# Receiver sensitivity comments against 802.3cu D2.0 #29, 77, 78, 83, 84, 96, 102, 111

April 14, 2020 Interim Teleconference

IEEE P802.3cu 100 Gb/s and 400 Gb/s over SMF at 100 Gb/s per Wavelength Task Force

Figure 140–5—Illustration of receiver sensitivity

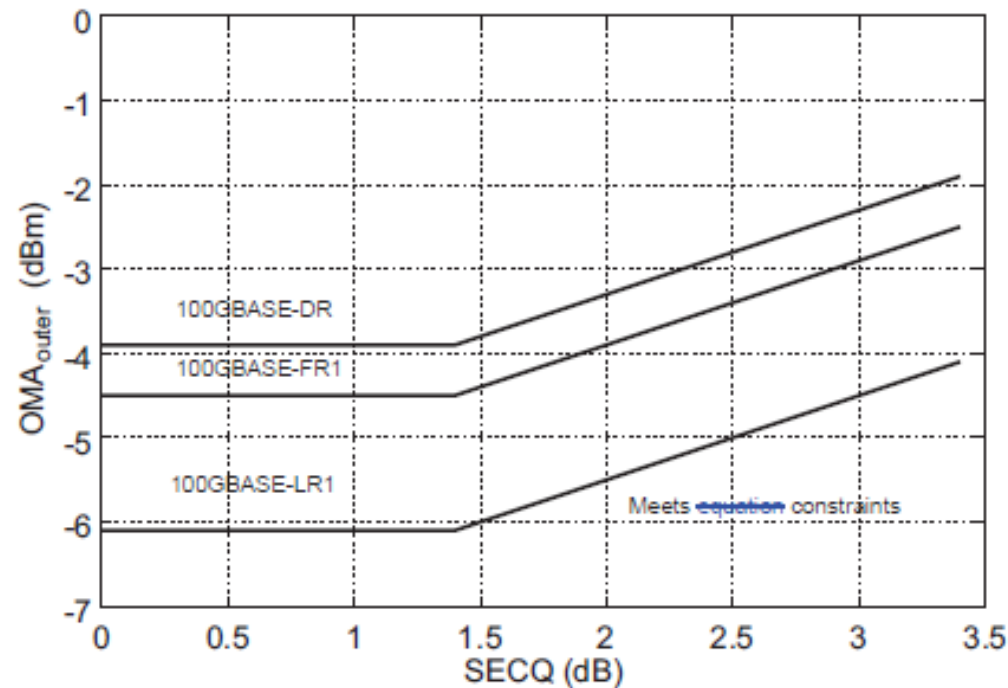
*Change the contents of 140.7.9 and Figure 140-5 as follows:*

Receiver sensitivity for 100GBASE-DR is informative and is defined for a transmitter with a value of SECQ up to 3.4 dB. Receiver sensitivity for 100GBASE-DR should meet Equation (140-1), which is illustrated in Figure 140-5. The normative requirement for the 100GBASE-DR receiver is stressed receiver sensitivity.

~~The normative requirements for the 100GBASE FR1 and 100GBASE LR1 receivers include both receiver sensitivity and stressed receiver sensitivity.~~

~~Receiver sensitivity for 100GBASE FR1 is defined for a transmitter with a value of SECQ up to 3.4 dB. Receiver sensitivity should meet Equation (140-2), which is illustrated in Figure 140-5.~~

~~Receiver sensitivity for 100GBASE LR1 is defined for a transmitter with a value of SECQ up to 3.4 dB. Receiver sensitivity should meet Equation (140-3), which is illustrated in Figure 140-5.~~

The SECQ of the conformance test signal is measured according to 140.7.5, except that the test fiber is not used. The measured value of SECQ is then used to calculate the limit for receiver sensitivity ( $OMA_{outer}$ ) as specified in Table 140–7 and illustrated in Figure 140–5.

The receiver sensitivity ( $OMA_{outer}$ ) shall be within the limits given in Table 140–7 for 100GBASE-FR1 and 100GBASE-LR1, if measured using a test pattern specified for receiver sensitivity in Table 140–10.

The conformance test signal applied at TP3 meets the requirements for a 100GBASE-FR1 or 100GBASE-LR1 transmitter followed by an attenuator.

Figure 151-6—Illustration of receiver sensitivity for 400GBASE-FR4 and 400GBASE-LR4-6

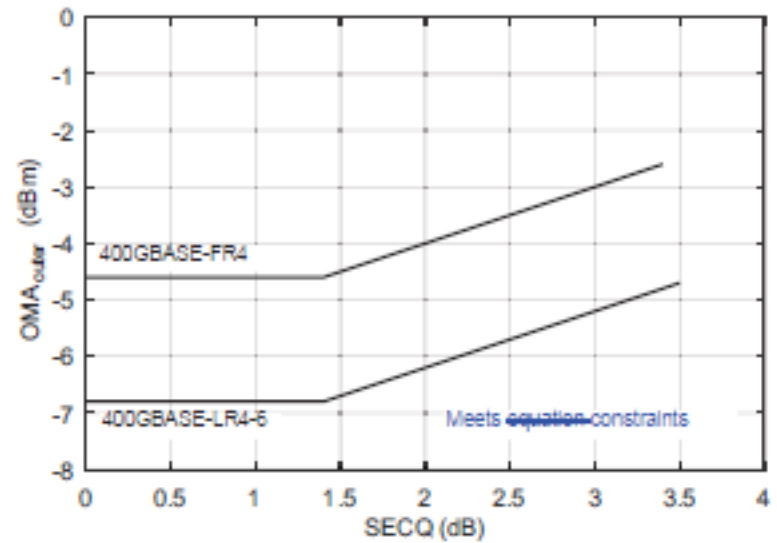
The SECQ of the conformance test signal is measured according to 151.8.5, except that the test fiber is not used. The measured value of SECQ is then used to calculate the limit for receiver sensitivity ( $OMA_{outer}$ ) as specified in Table 151-8 and illustrated in Figure 151-6.

~~For 400GBASE-FR4, receiver sensitivity is defined for a transmitter with a value of SECQ up to 3.4 dB. Receiver sensitivity should meet Equation (151-1), which is illustrated in Figure 151-6.~~

~~For 400GBASE-LR4-6, receiver sensitivity is defined for a transmitter with a value of SECQ up to 3.5 dB. Receiver sensitivity should meet Equation (151-2), which is illustrated in Figure 151-6.~~

The receiver sensitivity ( $OMA_{outer}$ ) of each lane shall be within the limits given in Table 151-8 for 400GBASE-FR4 and 400GBASE-LR4-6, if measured using a test pattern specified for receiver sensitivity in Table 151-11.

The conformance test signal applied at TP3 meets the requirements for a 400GBASE-FR4 or 400GBASE-LR4-6 transmitter followed by an attenuator. An optical demultiplexer may be used to separate the lane having the wavelength for the lane under test as specified in Table 151-8 for calibrating the SECQ.
